**Application for Encroachment Agreement  
267½ Glenholme Avenue (Amended)**

<b>Date:</b>	February 8, 2007
<b>To:</b>	Etobicoke York Community Council
<b>From:</b>	Curtis Sealock, Manager, Municipal Licensing and Standards
<b>Wards:</b>	Ward 17 - Davenport
<b>Reference Number:</b>	ML&S Folder No. 06-139427 RAW

**Attachment 4: Garage Detail**

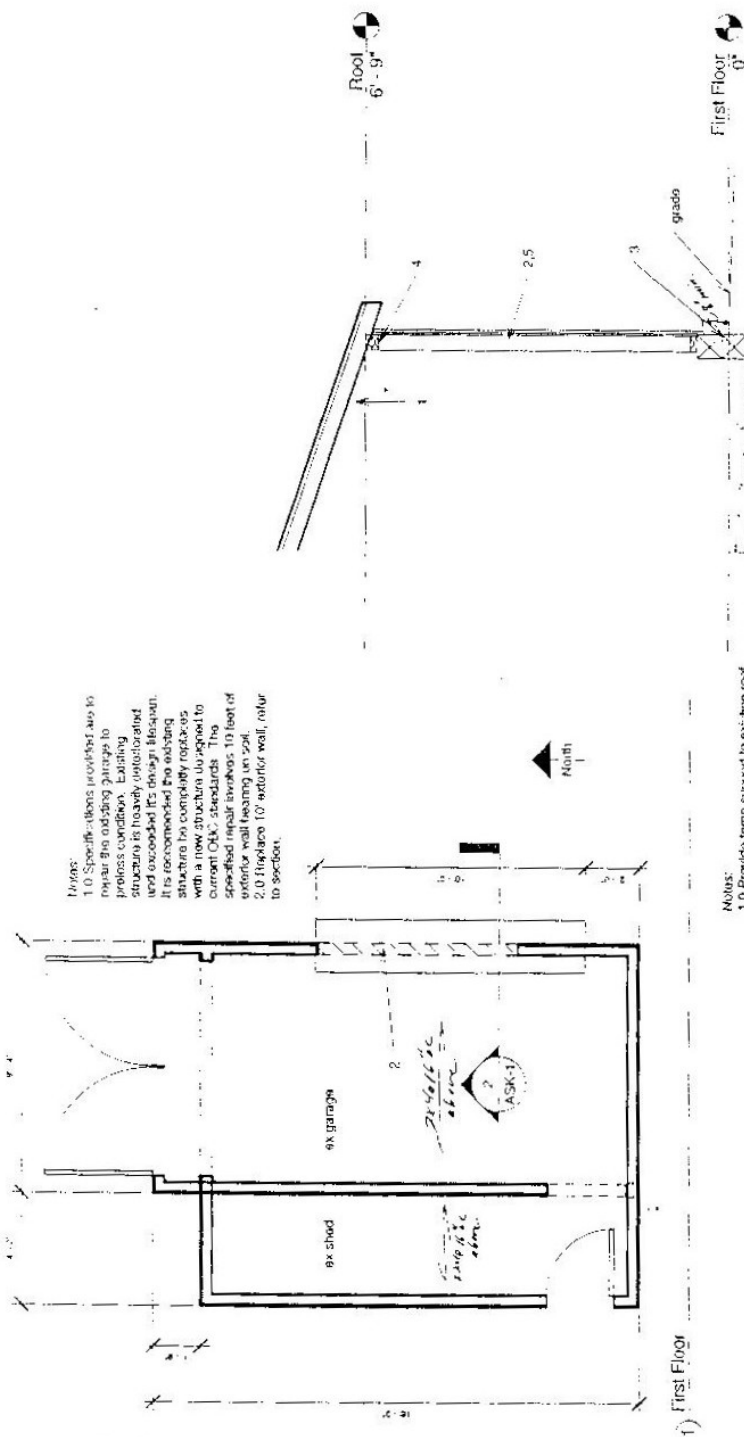
6. the owner to obtain a construction/streets occupation permit prior to the commencement of any construction;
7. the dilapidated garage to be repaired in accordance with Chapter 629 of the Toronto Municipal Code, Property Standards, and, should the repairs involve any structural alteration, drawings for a Building Permit are to be submitted to Toronto Building for approval – Attachments 4 and 6;

**Attachment 5: Hydro Requirements**

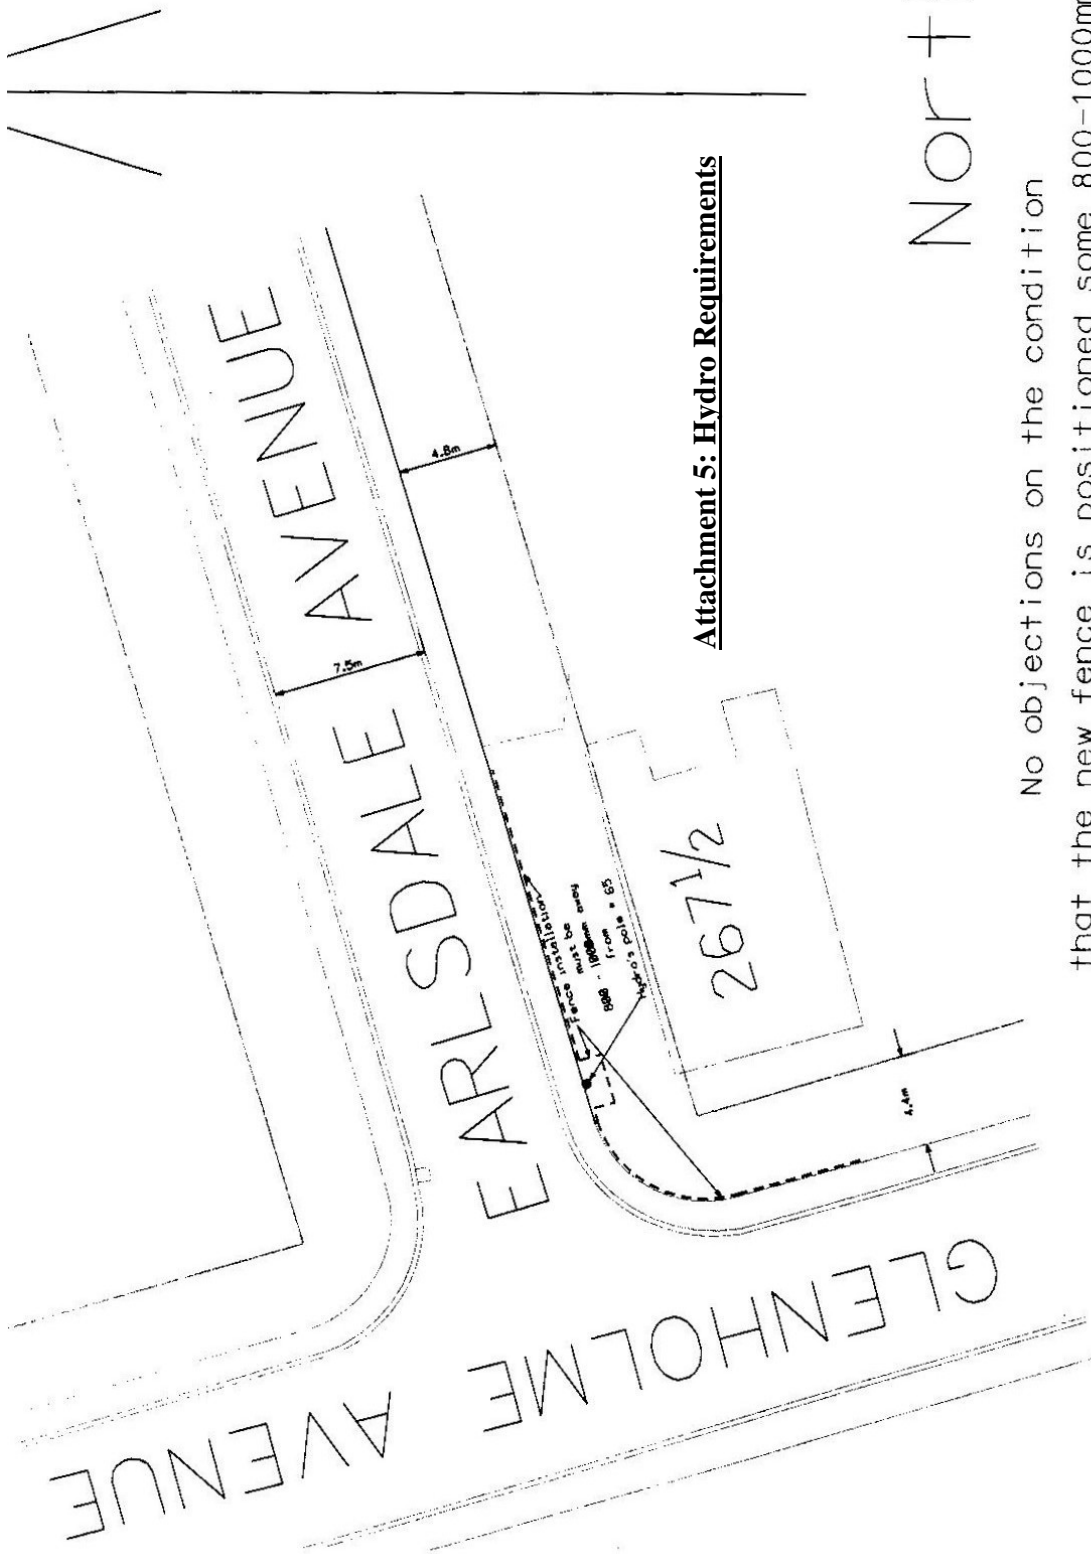
No objections on the condition that the new fence is positioned some 800-1000mm away from the perimeter of our Hydro pole# 65 !

3. the subject chain link fence to be kept in a state of good repair and maintenance, and, should the fence be replaced in future, it has to be realigned to allow a clearance of 800 mm – 1000 mm from the existing hydro pole on the Earlsdale Avenue road allowance, in compliance with the requirements of Toronto Hydro – Attachments 5 and 8;
